## **Groundwater Transfer Review Summary Form**

Transfer/PA # T- <u>13280</u>

SINTE OF OREGON			<b>Ground Water Review Form:</b>						
WRD S	<b>Oregon Water Resources Department</b> 725 Summer Street NE, Suite A Salem, Oregon 97301-1271 (503) 986-0900 www.wrd.state.or.us		<ul> <li>Water Right Transfer</li> <li>Permit Amendment</li> <li>GR Modification</li> </ul>						
							□ Other		
						Application: T- <u>13280</u>			Applicant Name: Swan Lake North Holdings
Proposed Change			es: 🗆 POA	APOA	$\Box$ SW $\rightarrow$ GW	$\Box$ RA			
	🖾 USE	🛛 POU	□ OTHER						
Reviewer(s): <u>M</u>	lichael Thoma		Date of Review: <u>08/21/2020</u>

- Basic description of the changes proposed in this transfer: <u>This transfer application is in</u> conjunction with HE-617 for development of a power-generation hydroelectric project. HE-617 includes details on the initial fill of the hydroelectric reservoirs and this transfer is for annual maintenance of those reservoirs, including to cover annual water loss to the system (e.g., evaporation). This application proposes changes to Cert. 92375 and Cert. 87006. Cert. 92375 currently authorizes use of three (3) POAs (gw\_logids: KLAM0002263, KLAM0002259, a

# Estimated drawdown at nearest groundwater POD from use at 2 AF/acre representing "historical" duty; rate is averaged over entire irrigation season

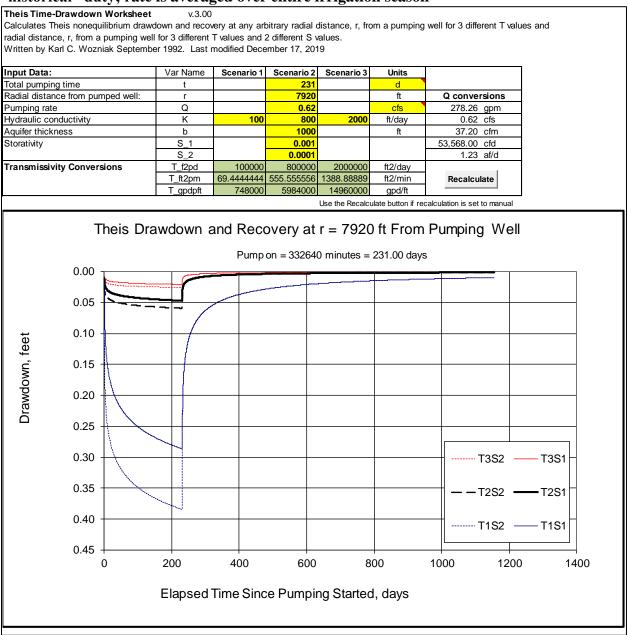
The applicant proposes to change the character of use from irrigation to reservoir maintenance. Reservoir maintenance use is proposed at the full duty assigned on the water right of 3 AF/acre. It is very likely that the current and historical use on these certificates has not been full exercise of this 3 AF/acre duty which appears to be an unreasonably high duty when compared to water-use data collected elsewhere in the Klamath Basin. The increase in actual duty from historical use would be brought about by an increase in average pumping rate over the irrigation season and result in an increase in drawdown at nearby groundwater POAs compared to historical interference.

Yes No Comments: Despite the increase in total duty and average pumping rate that is likely to occur with the change in use proposed on this application, interference to nearby groundwater POAs is not likely to be great enough to be considered injury per OWRD standards. The increase in drawdown to the nearest existing groundwater POA (not operated by the applicant), which is approximately 1.4 miles away, is estimated to be less than 0.2 ft compared to historical interference.
